Nov. 27,2025

MCRQ、MCRQ-S、MCSF-5 Series Specification Change Notification

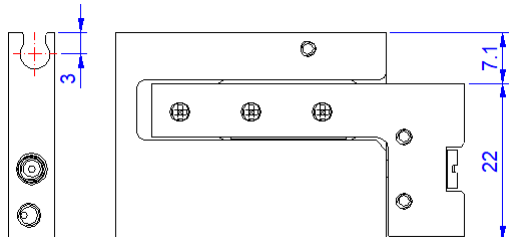
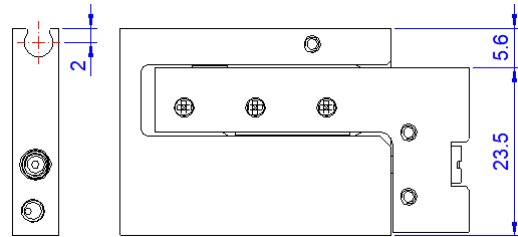
Before	After
1. Model : MCRQ、MCRQ-S Model : MCSF-5 2. Sensor switch : RDFE(V)、RNF(V)、RPF(V)	1. Model : MCRQ 2 、MCRQ 2 -S Model : MCSF 2 -5 2.Sensor switch : RDC(V)、RQC(V)
MCSF-5 	MCSF2-5

MCRQ~~2~~、MCRQ~~2~~-S : 2026.02.05
MCSF~~2~~-5 : The replacement model will be implemented as the standard offering when the existing inventory of the discontinued models is exhausted.
